Response to the NSW Trigger Processor PRR report

13 March 2020

This document addresses the issues to be clarified that were identified by the reviewers in the NSW Trigger Processor Production Readiness Review, 14 October 2019. Their report is at:

sTGC L1A data payload

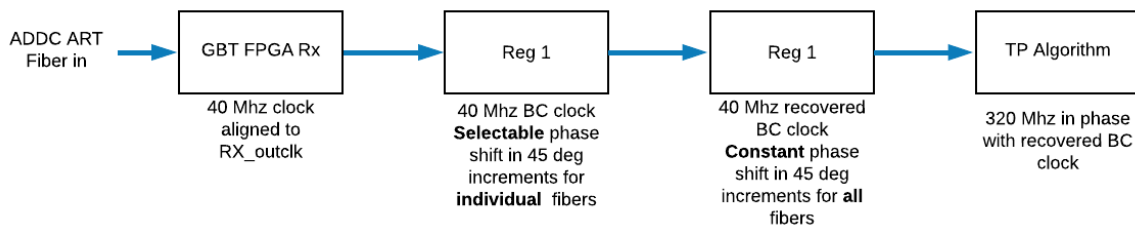
For $\mathcal{L} = 5 \times 10^{34}$, the table below shows that the expected number of 320Mb/s E-links needed for the sTGC Trigger Processor is 1.36. Scaling to the expected Run 3 luminosity of 3×10^{34} , we require 0.8 320 Mb/s E-link. Note that six such E-links are available.

16	bits for header	
104	bits per input TDS	104 means no compression
8	layers	
1.33	average no of bands per BC. This is an exaggeration.	
3	BCs per L1A	
0.100	L1A rate, MHz	
348	Mb/s	(435 bytes/L1A)
435	Mb/s with 8b/10b	
1.36	# E-links	@ $\mathcal{L} = 5 \times 10^{34}$
